Sand and Gravel Individual Permit Application

Summary of Comments on 2016-G011 City of San Marcos-application_Redacted-highlighted-errors.pdf

CAPE DAM-BREACH & CHANNEL RESTORATION

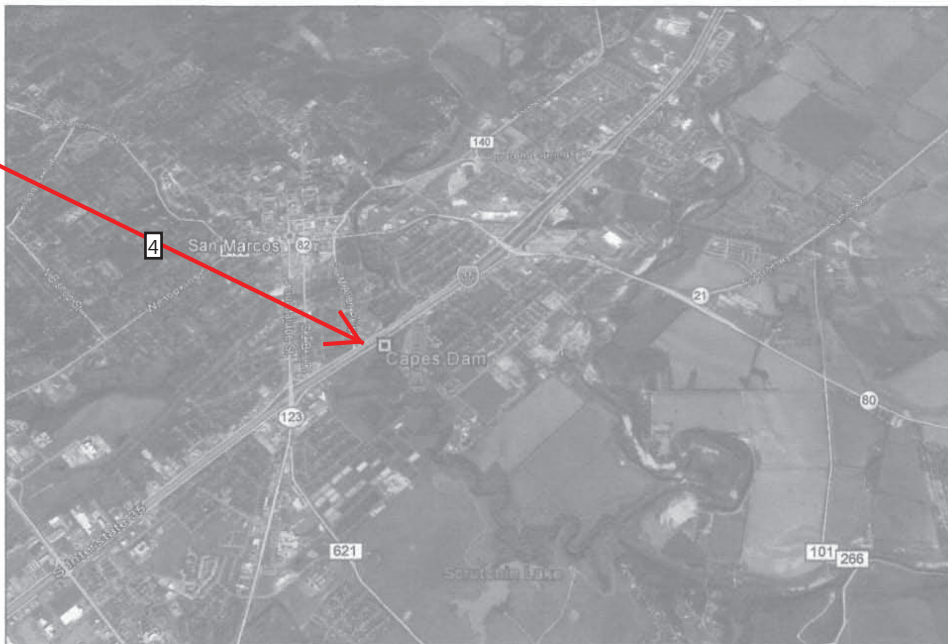
3 Aerial photograph incorrectly shows the location of Capes Dam

Aerial photograph is outdated and does not show the Wood Apt Complex
See Attachment A for a complete discussion of shortfalls of this page.

SAN MARCOS, TEXAS		EXISTING & PROPOSED		SUB-SHEET	
CAPES DAM-BREACH & CHANNEL RESTORATION		ALIGNMENT PROFILE DETAILS		4	
DESIGNED R. STANFILL	DRAWN W. STANFILL	CHECKED W. ROSE	DATE 3/2018	DRAWING NO. 98-20-2018-200	SHEET 4 OF 4

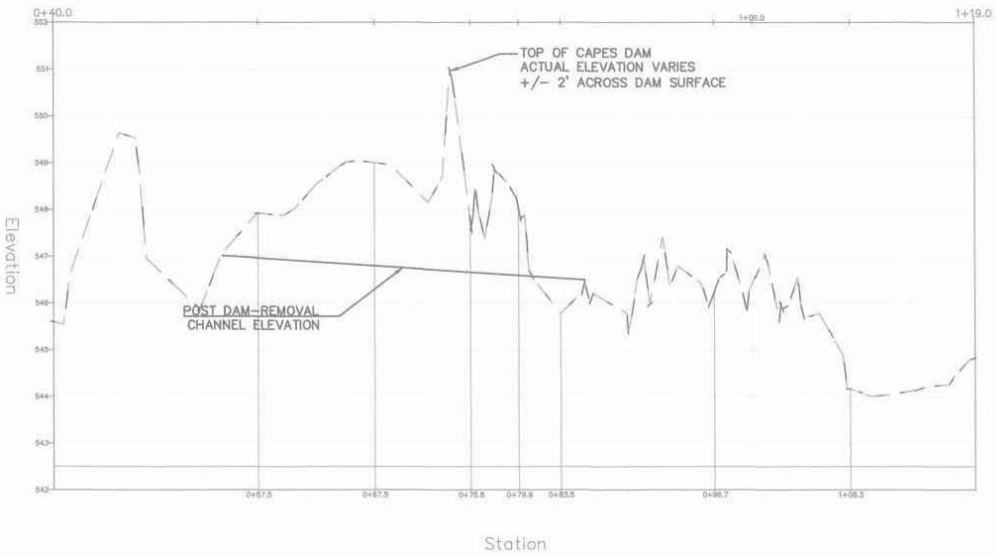
1 See Attachment A for a complete discussion of shortfalls of this page.

2
What is the date of these measurements?
Where is a key-map showing location of measurement stations?
Is this a graph over time? Or what is the x-axis supposed to represent? Time or location or both?

SAN MARCOS, TEXAS		EXISTING SITE SECTION LINE DETAILS		SUB-SHEET
CAPES DAM-BREACH & CHANNEL RESTORATION				5
DESIGNED BY	DRAWN BY	CHECKED BY	DATE	DRAWING NO.
R. STANCK	R. STANCK	M. REE	4/2018	BB-14-2018-000
				SHEET
				3 OF 3

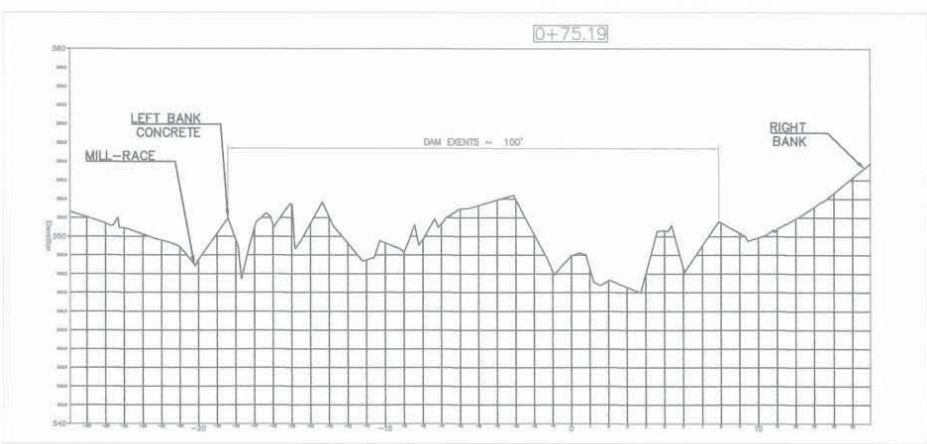
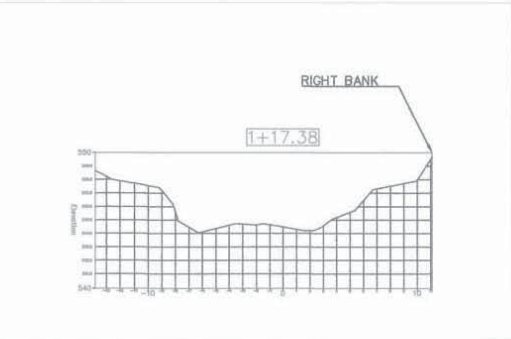
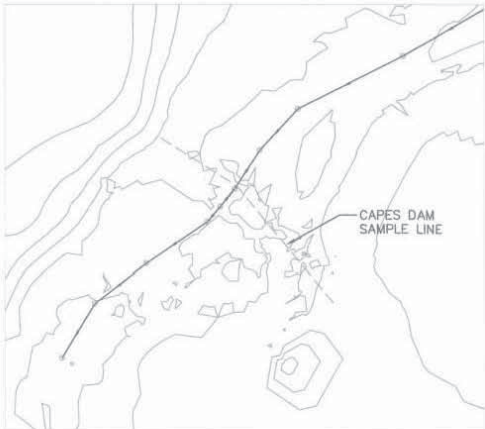
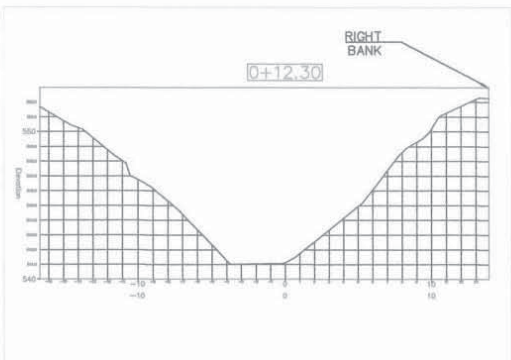
See Attachment A for a complete discussion of shortfalls of this page.

SAN MARCOS, TEXAS		PROPOSED SITE			SUB-9-027
CAPES DAM-BREACH CHANNEL RESTORATION		SECTION LINE DETAILS AT DAM			6
DRAWN W. STUBBS	CHECKED W. STUBBS	DATE 5/2/18	DRAWING NO. 00-15-2018-002	SHEET 8 OF 7

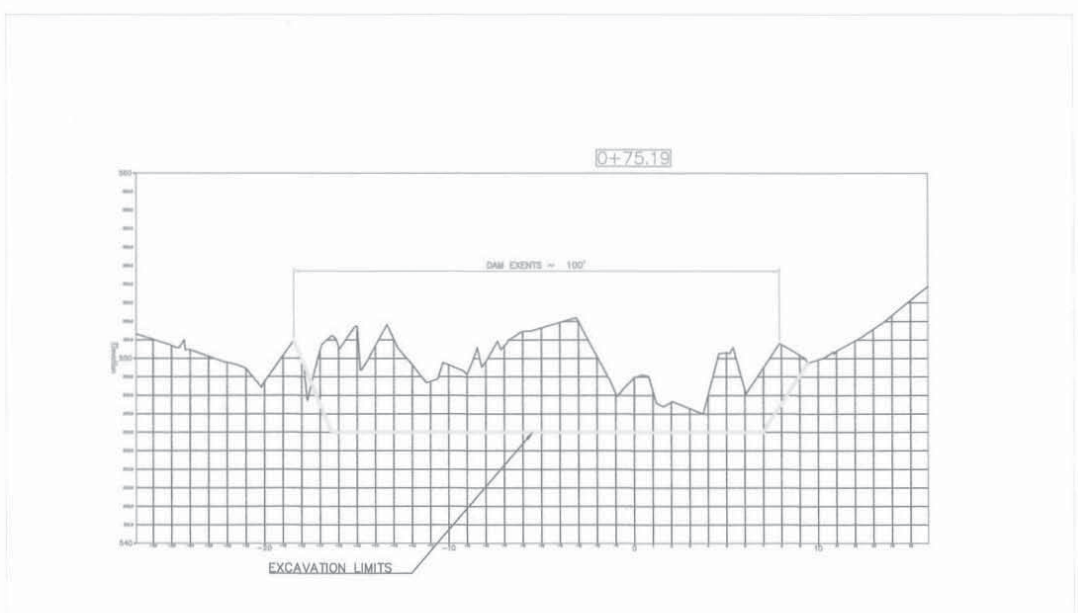
See Attachment A for a complete discussion of shortfalls of this page. 1

SAN MARCOS, TEXAS		MILL RACE GRADE CONTROL		SUB-SHEET	
CAPES DAM-BREACH & EROSION CONTROL DETAILS				7	
DESIGNED W. STAMMILL	DRAWN W. STAMMILL	CHECKED E. REICE	DATE 5/2016	DRAWING NO. 88-TC-2016-006	SHEET 7 OF 7

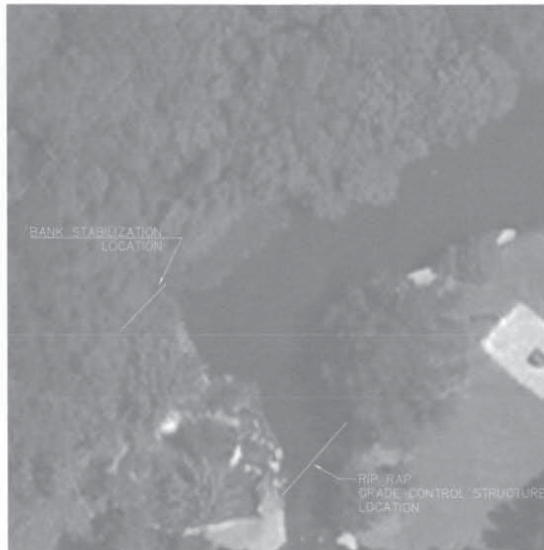
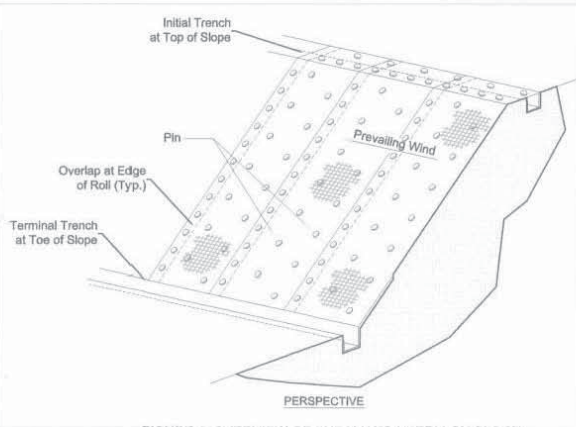
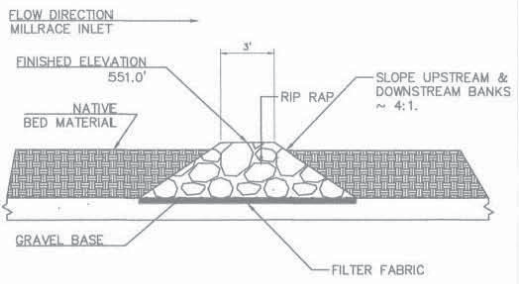
See Attachment A for a complete discussion of shortfalls of this page. 1
